Arborist Report

Site: 4332 W Mercer Way, Mercer Island, WA, 98040

Re: Tree Inventory and Assessment

Date: May 9, 2024

Figure 2. Proposed Site Plan A1.0 (Ectypos Architecture, 05/11/2024).

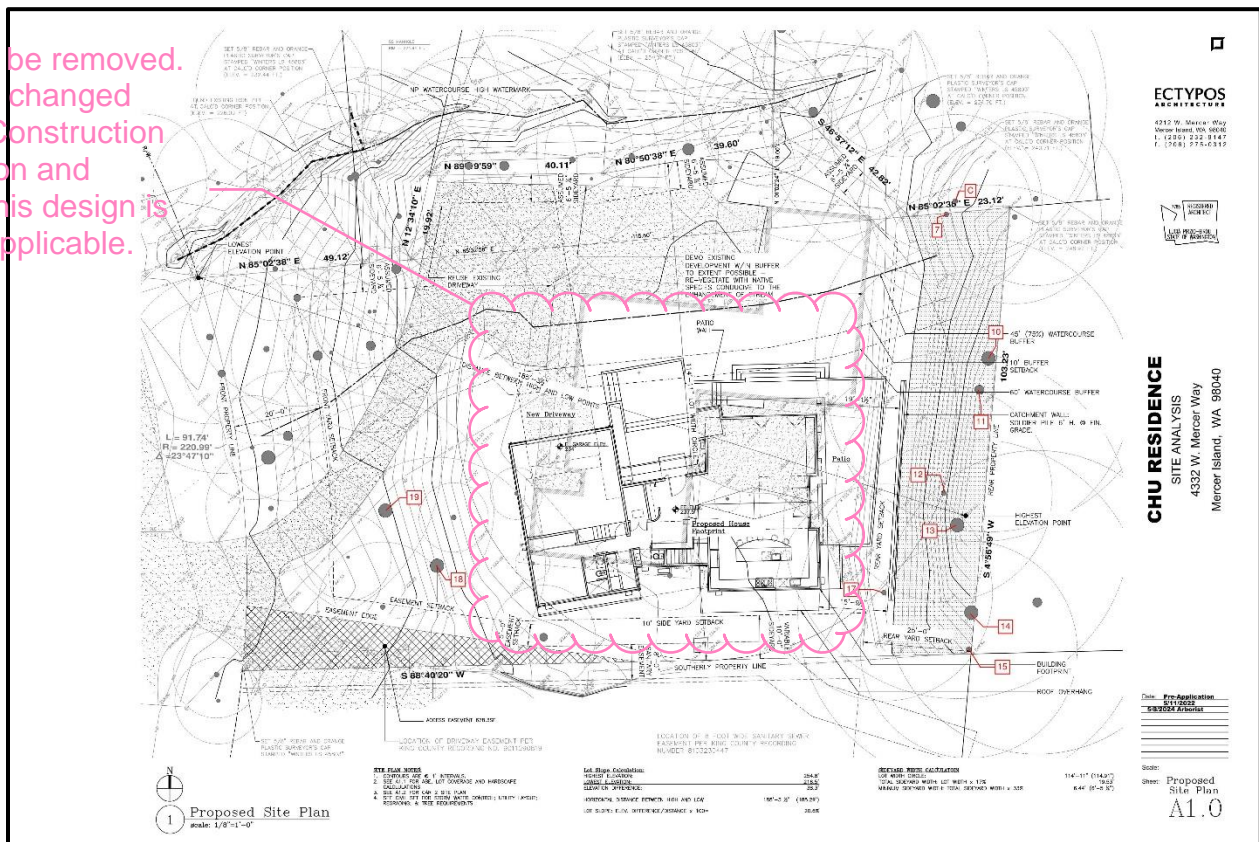
No tree will be removed. The project changed from New Construction to Alternation and Addition. This design is no longer applicable.

Figure 3. Civil Plan Sheet C-2 (Nick Bossoff Engineering, 05/07/2024)

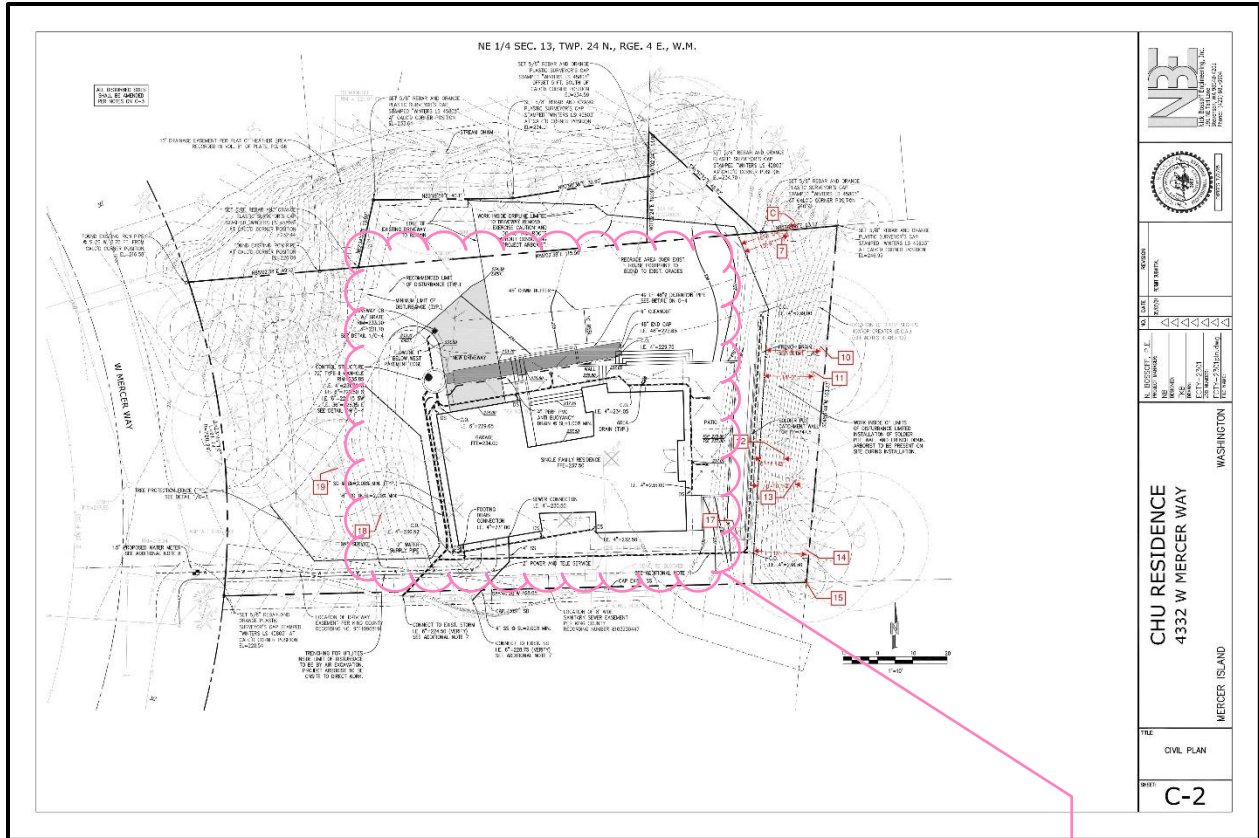
No tree will be removed. The project changed from New Construction to Alternation and Addition. This design is no longer applicable.

TOPOGRAPHIC SURVEY
4332 WEST MERCER WAY
MERCER ISLAND, WASHINGTON

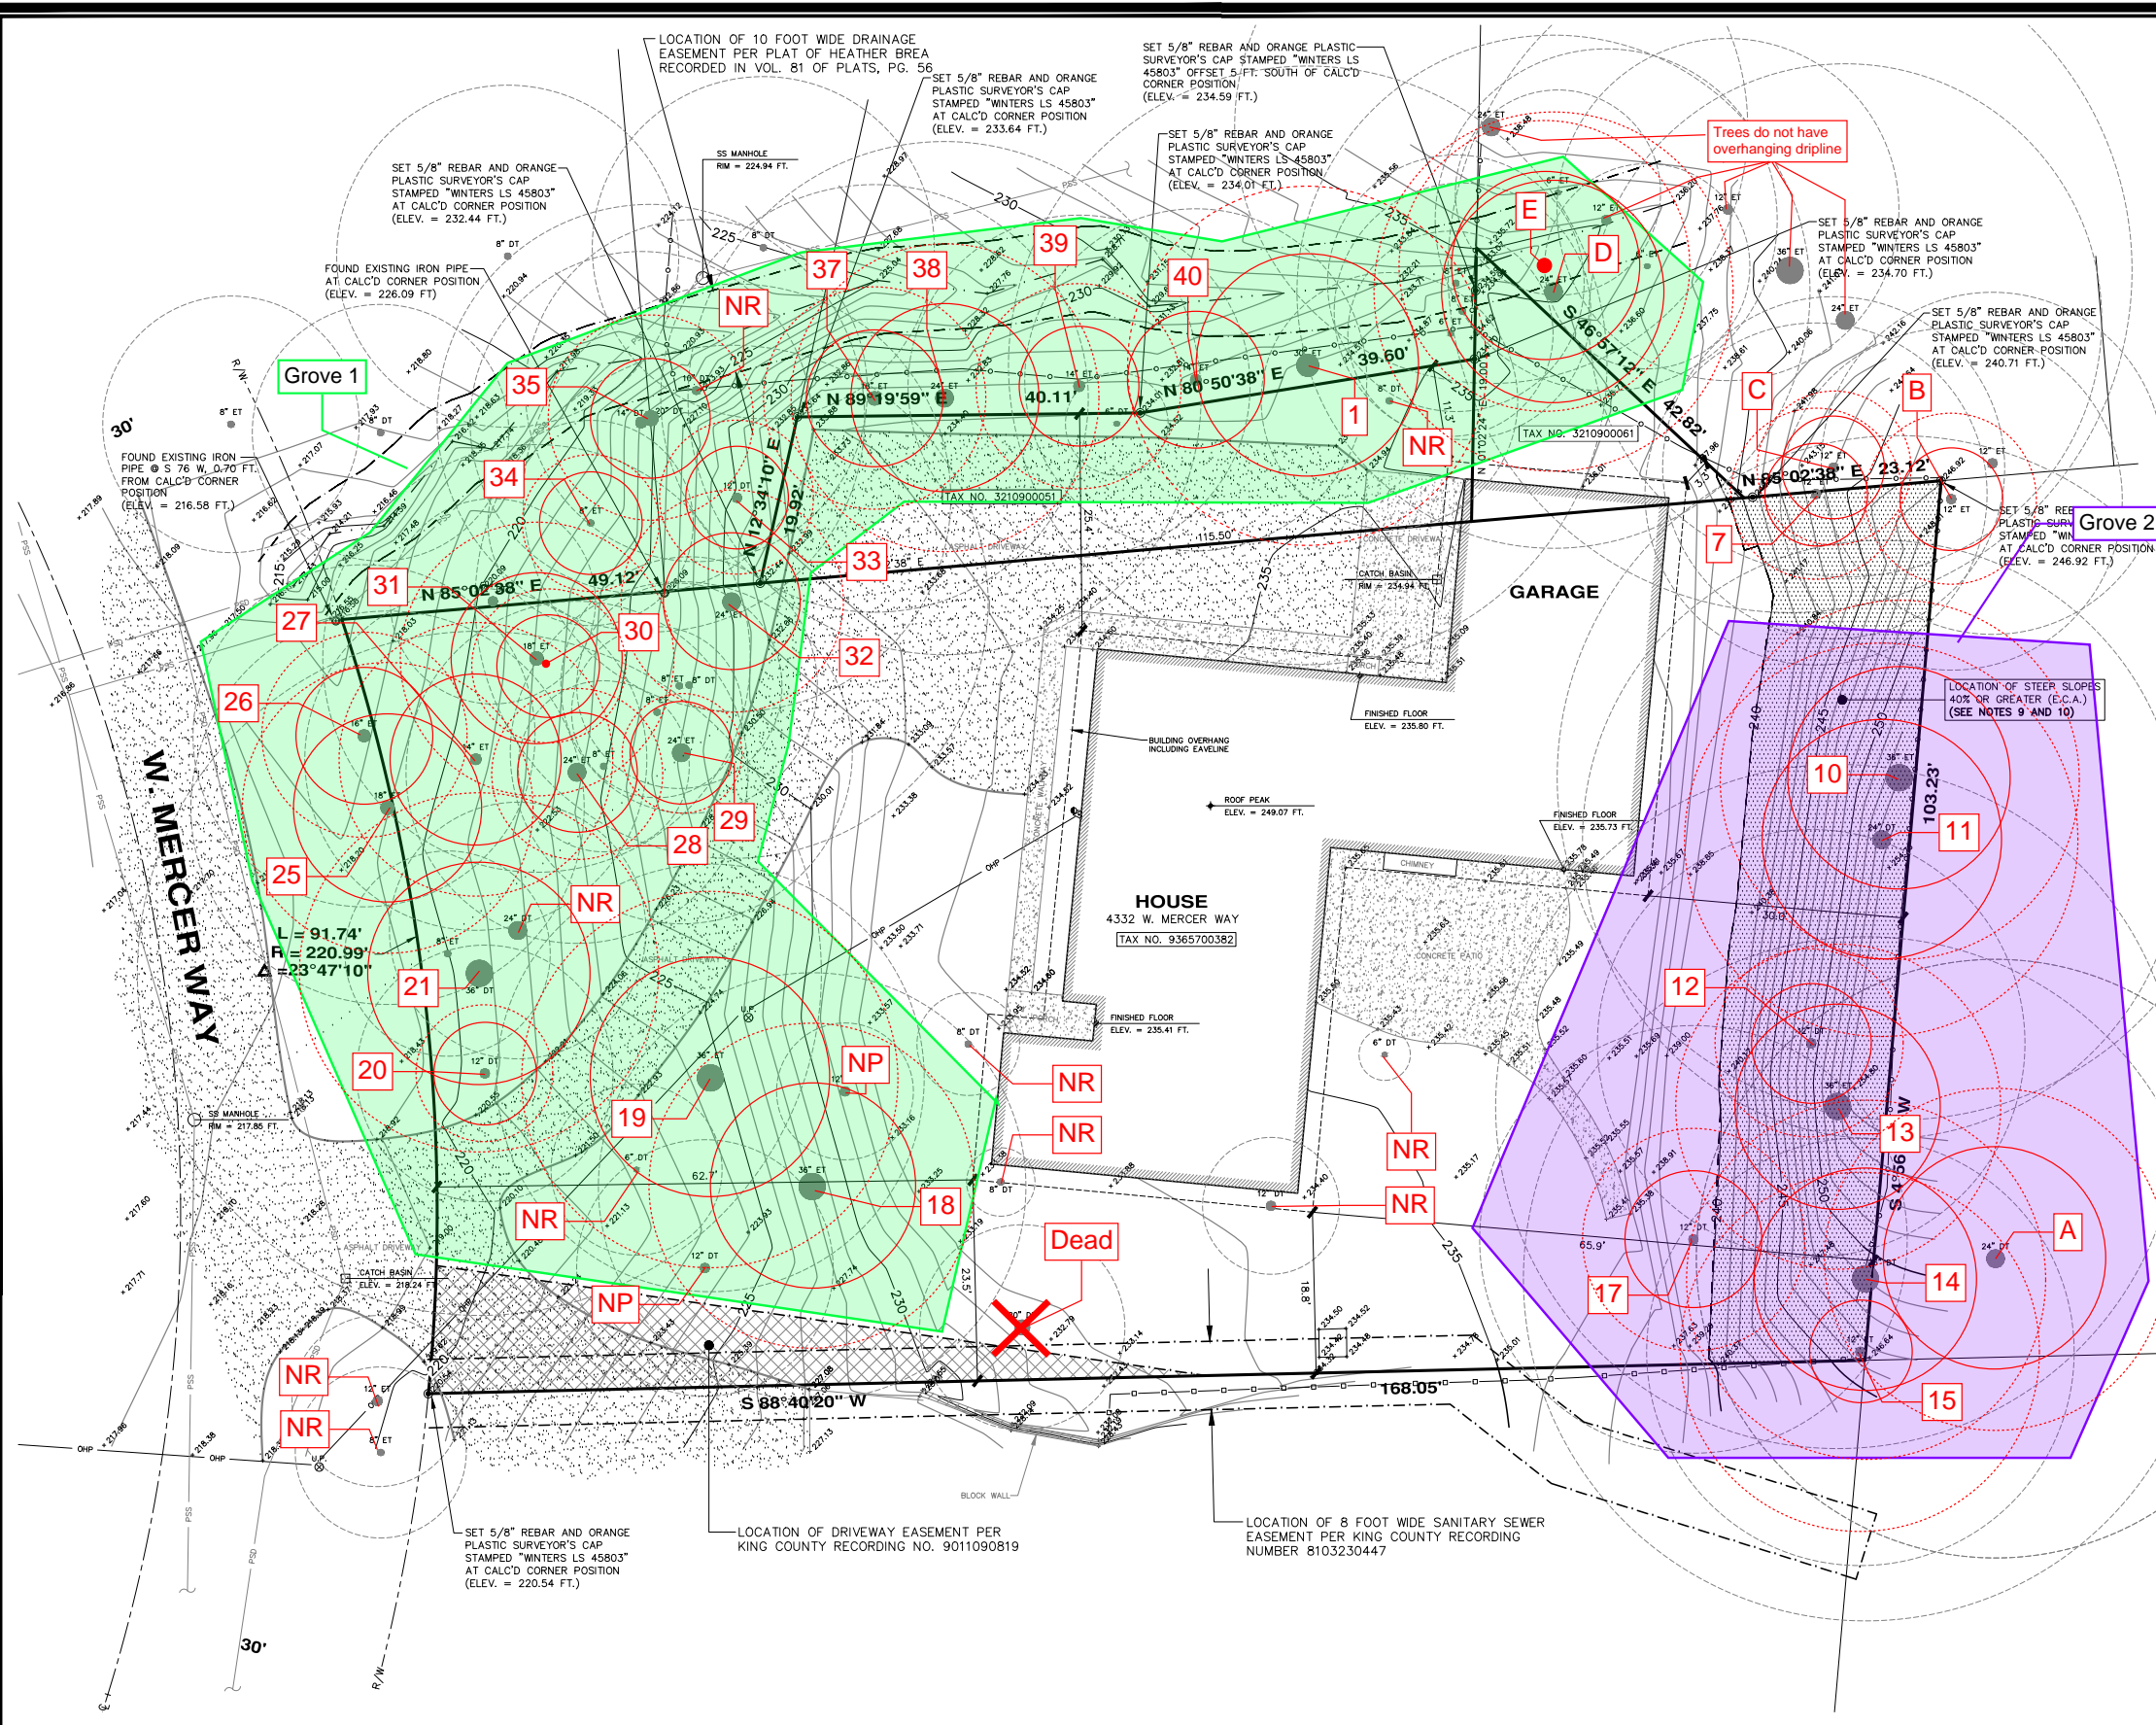
Survey and site plans should be updated to include tree identifiers and accurate dripline data prior to any design related to tree protection.

*Tree locations added to the survey are approximate and should be confirmed and added to the survey.
